# Fassaroe Phase 1 Strategic Housing Development

Stage 1 Quality Audit

Cosgrave Property Group

April 2022

Figure 2-2 – Large Unmarked Parking Area

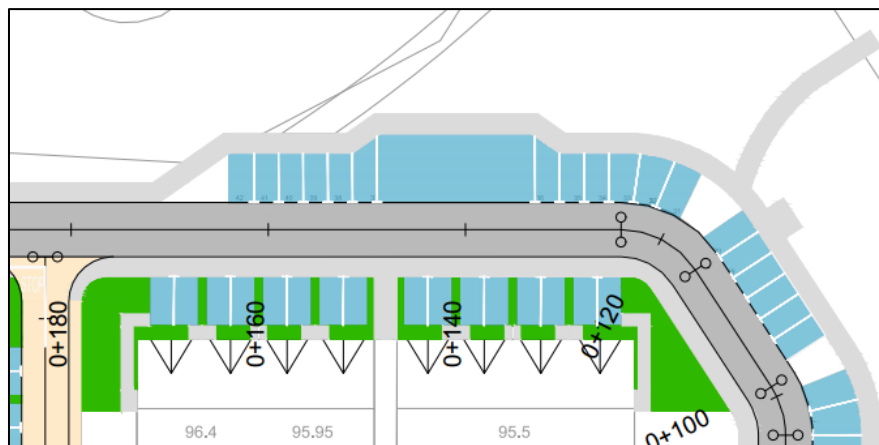
There is a large unmarked parking area adjacent to a local road carriageway which may result in poor parking discipline or positioning by drivers (shown in Figure 2-2). This hazard could lead to an increased risk of collision.

The parking area should be formalised.

**Figure 2-5 – Abrupt End to Footpath**

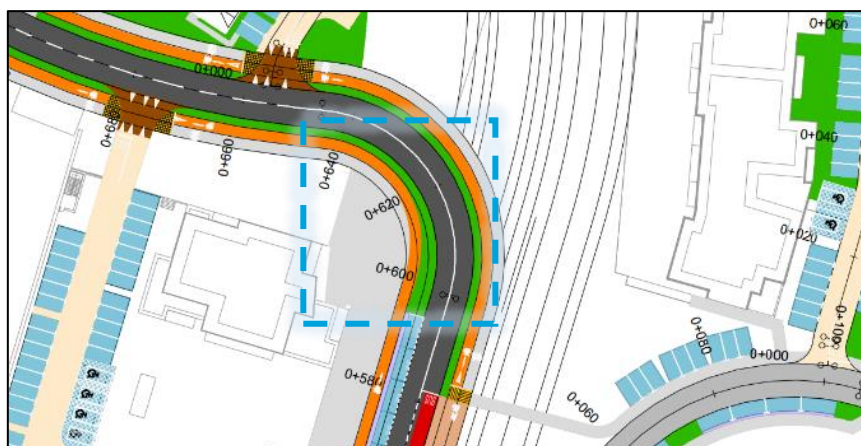
The proposed footpath ends abruptly and merges into a cycle track (shown below in Figure 2-5). This may result in the hazard of pedestrians unknowingly entering the cycle lane, or cyclists unknowingly entering the footpath. This could lead to head-on collisions between pedestrians and cyclists.

The footpath and cycle track terminations/alignments should be reviewed to remove the conflict.

**Figure 2-6 – Footpath Tie-in with Tramline Paving**

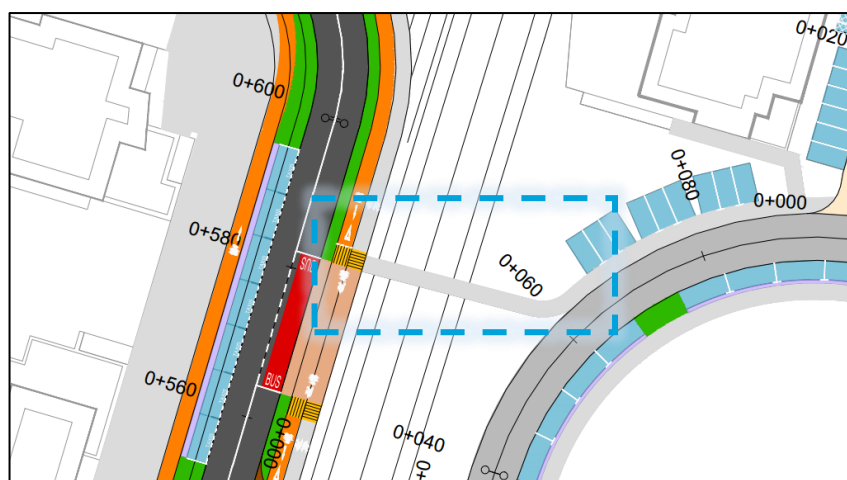
The proposed footpath ties in perpendicularly to the tramline paving of the shared area on the main road (as shown in Figure 2-6). This tramline orientation would indicate to visually impaired NMUs that they are entering onto a cycle track.

The footpath tie-in should be reconfigured to remove the potential for confusion for visually impaired users.

**Figure 2-7 – Parallel Parking on Inside of Bend**

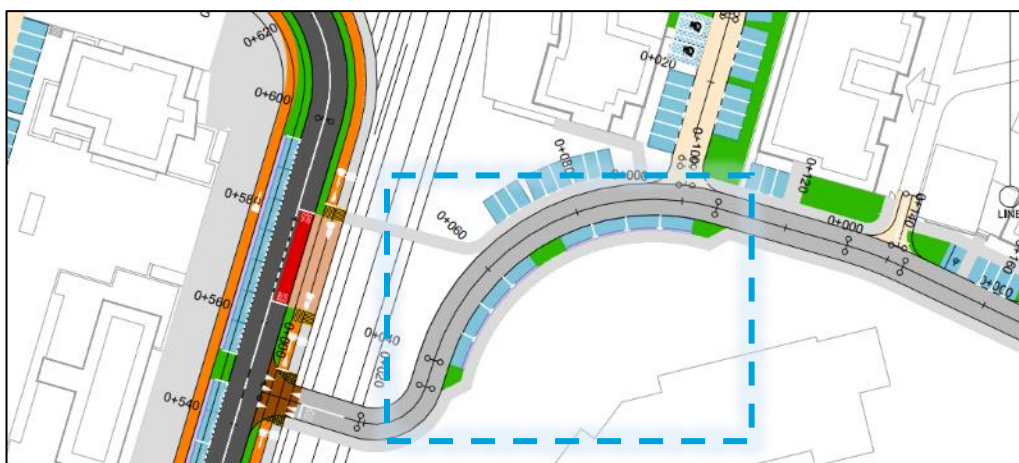
Road users attempting to use the proposed parallel parking (shown below in Figure 2-7) will likely tend to stop and reverse into a parking space. Other parked and adjacent vehicles may obstruct forward visibility to those vehicles stopped / reversing into the parking space, which may result in the risk of rear-end shunts by through traffic.

Sufficient visibility for through traffic should be confirmed, considering parked vehicles (including taller vans / 4x4s). If insufficient, the parking should be relocated or removed.

Figure 2-9 – Large Radii at Junction

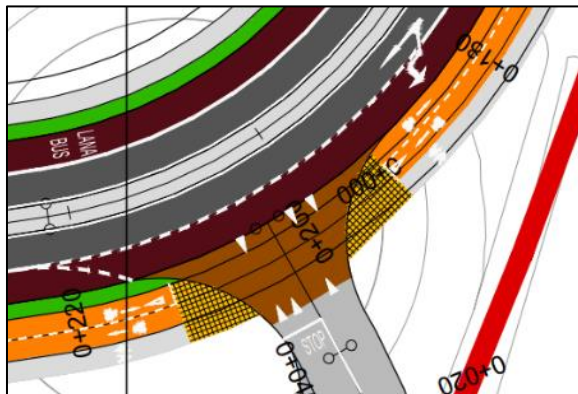
The large radii for the proposed junction (shown below in Figure 2-9) may result in increased speeds for road users, while increasing the crossing distance for NMUs. The combination of these factors may result in the risk of collisions between vehicles and NMUs.

The junction should be tightened, if possible, considering anticipated vehicle movements.

Figure 2-10 – Short Sections of Shared Areas

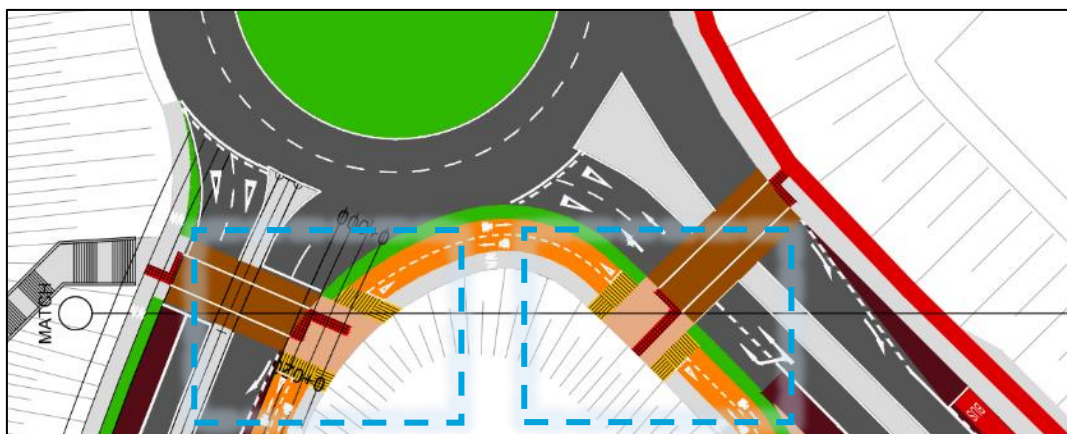
The proposed shared areas, facilitating two-way cycle tracks and a pedestrian footpath, have relatively short approach lengths, considering the potential number of users that may congregate in the area (shown below in Figure 2-10), and considering the possible speed of approach by cyclists. This may result in collisions between users.

The shared areas should be increased in size to enable more space for users to avoid one another.

Figure 2-11 – Proposed Road Markings

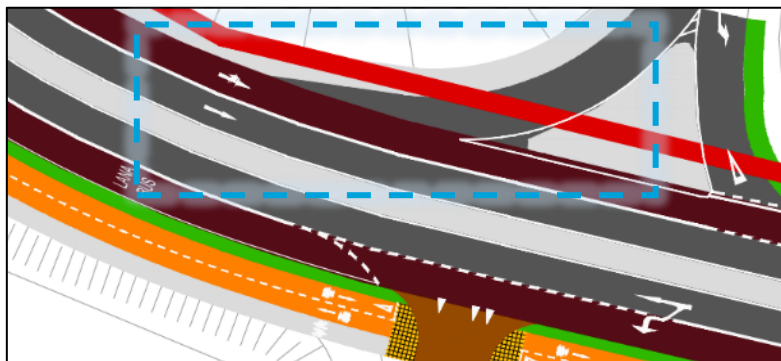
The proposed road markings at this location do not facilitate general vehicles to cross the bus lane to enter the junction (shown in Figure 2-11). This may result in unexpected manoeuvres leading to collisions between road users.

The Design Team should provide a broken line and a 'Bus Lane Ends arrow' (M 130L) to allow general vehicles to cross the bus line to enter the junction, as included on the northbound lane shown in Figure 2-11.

Figure 2-13 – Footpath Leads onto Carriageway

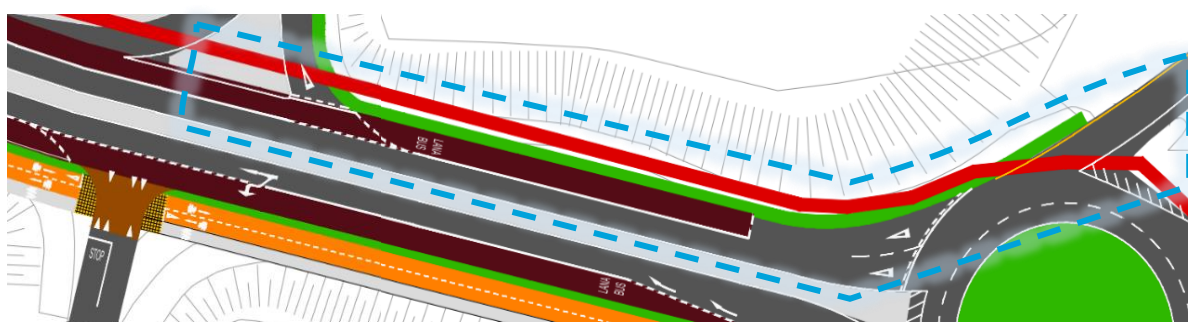
There is an existing footpath on the north side of the road which leads to a drop kerb onto the carriageway at the northbound exit from the roundabout (shown below in Figure 2-13). This leads pedestrians directly onto the carriageway with no pedestrian provision on the other side of the road. This arrangement may lead to the hazard of pedestrians traversing the carriageway, which could lead to the risk of collisions between vehicles and pedestrians.

The existing footpath should be removed (e.g. replaced with a grass verge, or similar).

**Figure 2-14 – Significant Change in Levels for Existing Ground**

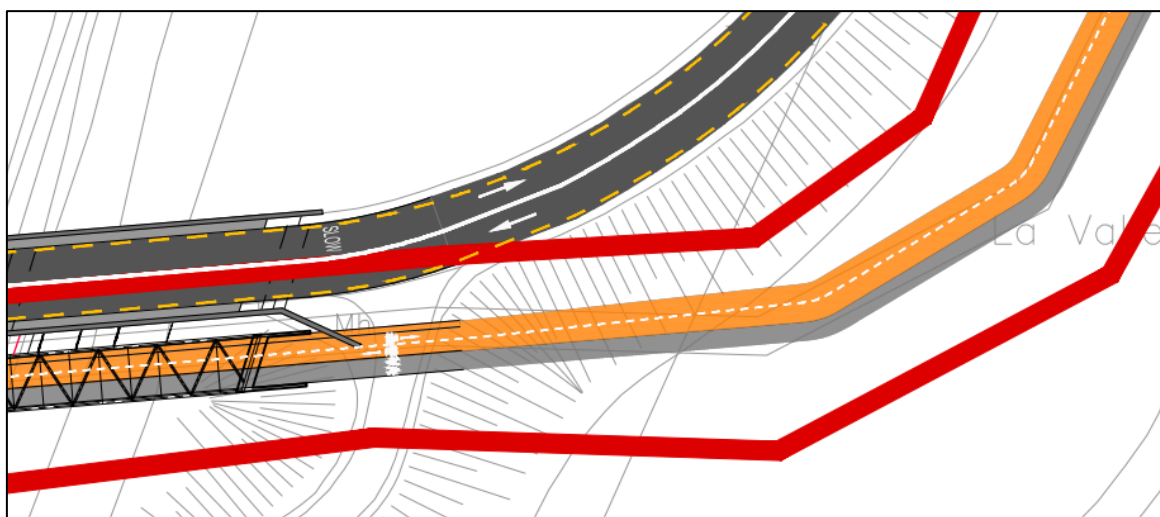
There are significant changes in existing ground levels where a footpath and two-way cycle track is proposed at the east end of this scheme (shown below in Figure 2-14). The proposed length of this facility, as allowed for in the design, may result in a steep incline / decline for NMUs. This would be especially problematic for wheelchair users and less-abled pedestrians, and would promote high speeds for cyclists; all of which may result in slips, trips and falls for NMUs. Steep drop offs may be a result, each side of the proposed facility, which could increase injury severity during falls.

The Design Team should ensure that gradients are suitable for NMUs, and sufficient protection is put in place at any steep side-slopes, such as parapets or fencing along the extents of the slope.

**Figure 2-15 – Footpath and Cycle Track Delineation**

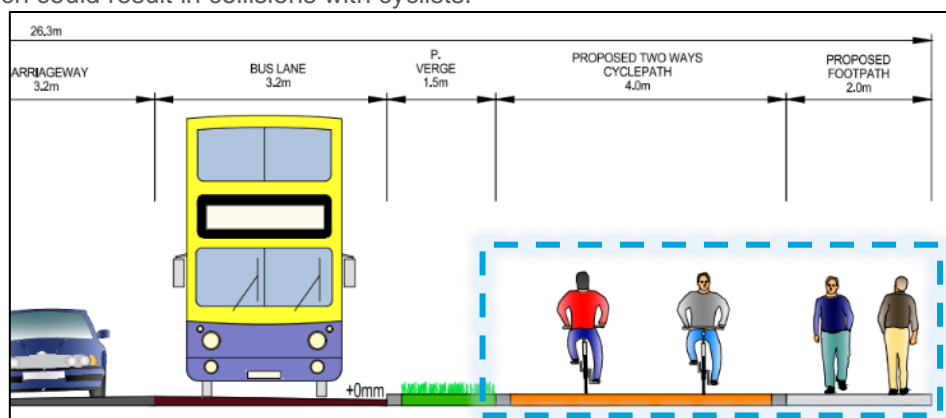
The proposed footpath and cycle lanes across the scheme are flush with no kerb in between. This may lead to the hazard of visually impaired pedestrians unknowingly straying onto the cycle track which could result in collisions with cyclists.

The Design Team should provide a delineating kerb in between the footpath and cycle lane to inform visually impaired pedestrians of the boundary of the footpath.

**Figure 2-16 – Provision for Turning areas for Vehicles**

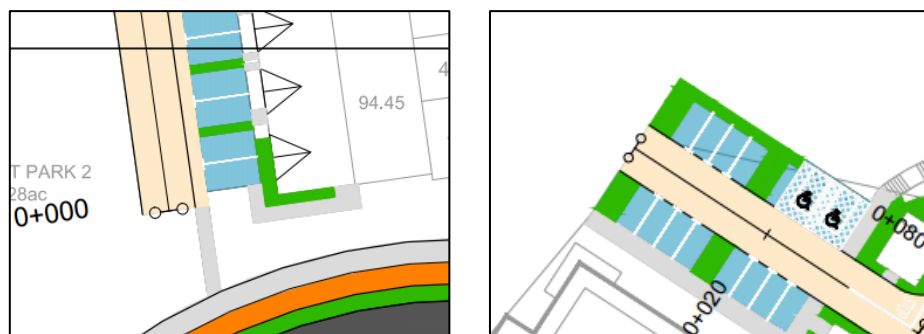
There are numerous cul-de-sacs on the homezone carriageways across the scheme that do not contain provision for vehicles to turn around (non-exhaustive examples shown in Figure 2-16), such as refuse vehicles. This may result in vehicles making multi-point turns or reversing along the road to the closest junctions where there is more space on the carriageway to perform a turning manoeuvre. These manoeuvres can increase the risk of conflict with pedestrians or other road users.

The Design Team should provide for vehicles to turn around at the cul-de-sacs.

**Figure 2-17 – Intersection of Existing Routes and Proposed Main Road**

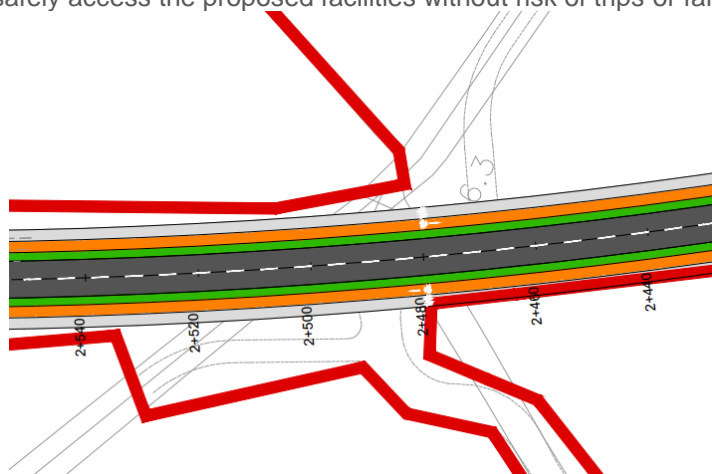
A number of existing routes intersect with the proposed main road (example shown in Figure 2-17). Adequate tie-in/transition provision for pedestrians and cyclists may be required to ensure that these users can safely access the proposed facilities without risk of trips or falls.

Where the scheme intersects with existing pedestrian / cycle access points, they should be suitably tied in.

Figure 2-18 - Trees Impeding Sightlines Across Scheme

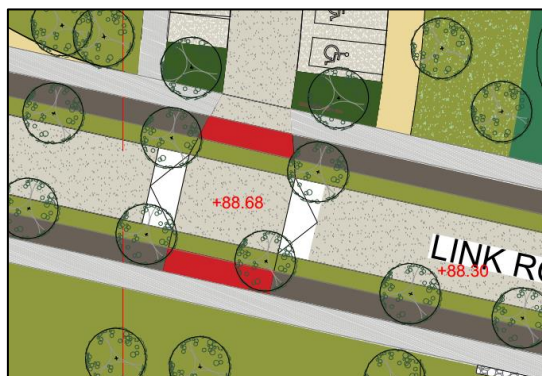
The proposed trees located along all roads in the scheme may impede sightlines for drivers and NMUs depending on the size and scheduled maintenance of the trees (example shown in Figure 2-18). If the trees are large in nature, with thick trunks or broad foliage, this may lead to collisions between drivers and NMUs (if visibility is blocked at crossings), or other drives (if visibility is blocked at junctions).

The species of tree should be reviewed to ensure their size is suitable and does not impinge on the safety of the scheme. The trees should be maintained regularly to ensure that foliage does not impede sightlines for NMUs or drivers.

Figure 3-1 – No Provision for Cyclists Turning Right

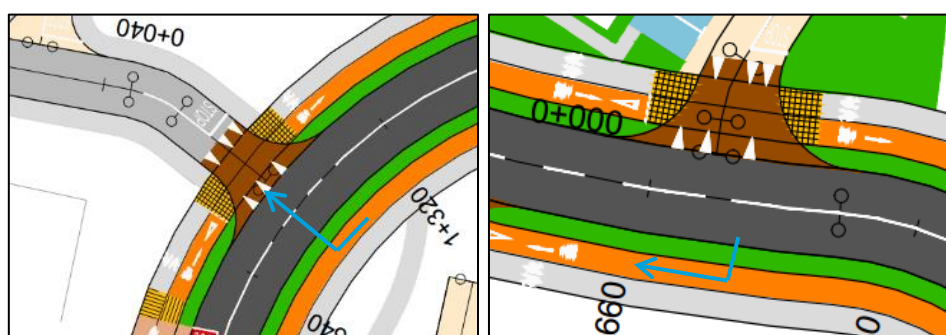
There are junctions across the scheme (non-exhaustive examples shown in Figure 3-1) that have no provision for cyclists to enter/exit from the other side of the road. Current arrangements expect cyclists to use crossings relatively far from the junction, which may result in cyclists crossing the verge or using the carriageway.

The Design Team should include provisions for cyclists to turn right at all such locations. The location of the proposed trees should be considered in-tandem, so that there is no inter-visibility issues with right-turning cyclists.

Figure 3-2 – Tactile Paving on Cycle Tracks

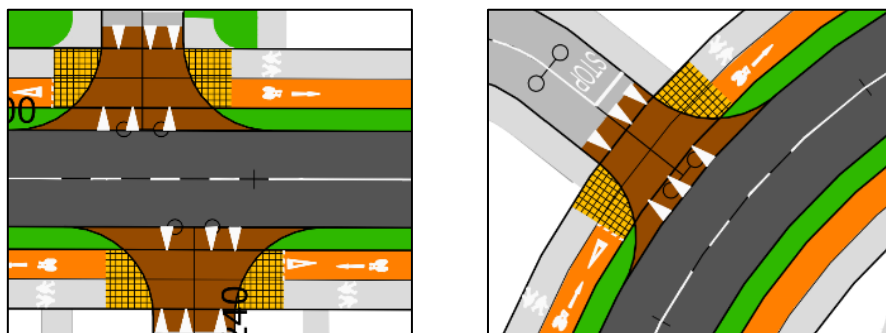
Across the scheme, tactile paving is shown on cycle tracks prior to and after junctions (shown in Figure 3-2). This may cause unnecessary destabilisation of cyclists at crossings.

Remove tactile paving at crossing points where they are for cyclists only.

Figure 3-3 – Right of Way for Junctions Across Scheme

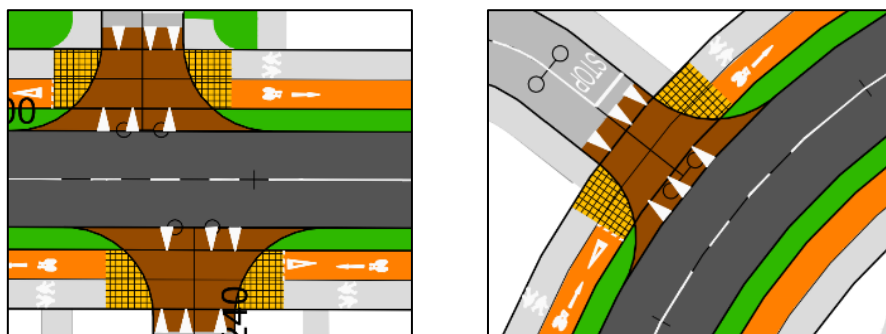
Across the scheme, junctions are designed to give right of way to vehicles while NMUs are expected to yield (as shown in Figure 3-3). DMURS states “*This Manual recognises the importance of assigning higher priority to pedestrians and cyclists, without unduly compromising vehicle movement, in order to create secure, connected places that work for all members of the community*”.

The Design Team should give priority to NMUs on these junctions.

**Figure 3-5 – Provision for Pedestrians at Roundabout**

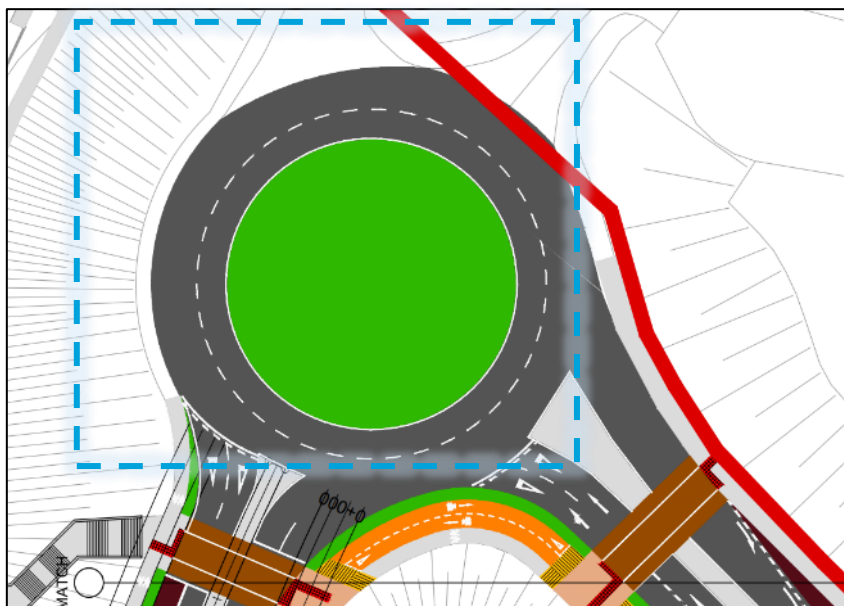
The footpath at chainage 0+000 of the scheme ends abruptly on the west side of the roundabout scheme (as shown in Figure 3-5). This may encourage pedestrians using the footpath to traverse the roundabout on the existing verge or on the main carriageway on the west side, which could result in collisions with vehicles. Furthermore, there is no ramp access to the residential area to the west, only steps are provided, which will present a barrier for access for mobility impaired users.

A footpath should be provided around the roundabout and a crossing on the northern arm to connect to the existing footpath on Thornhill Road. Provision for a ramp access to the residential area to the west should be provided for wheelchair users and cyclists.

**Figure 3-6 – Proposed Tactile Paving**

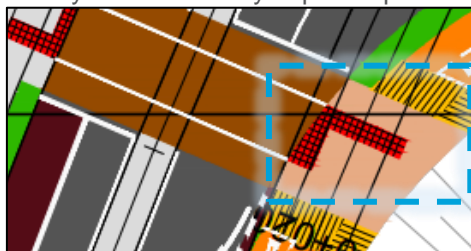
The proposed tactile paving at the toucan crossing does not extend to the back of the footpath (as shown in Figure 3-6). This may lead to visually impaired pedestrians being unaware of the crossing.

The tactile paving should be extended to the back of the footpath.

**Figure 3-7 – Lack of Direct Access to Playground**

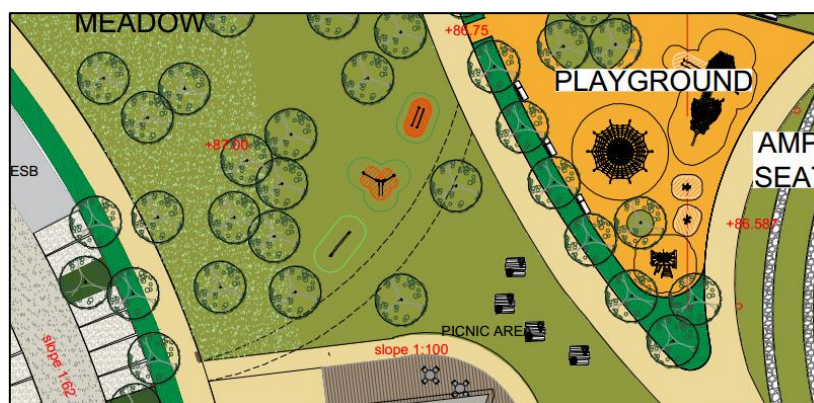
There is a lack of direct access to playground from the parking area to the west which may result in users walking across the grass along the dashed path (as shown in Figure 3-7).

A path should be provided between the parking area and playground.
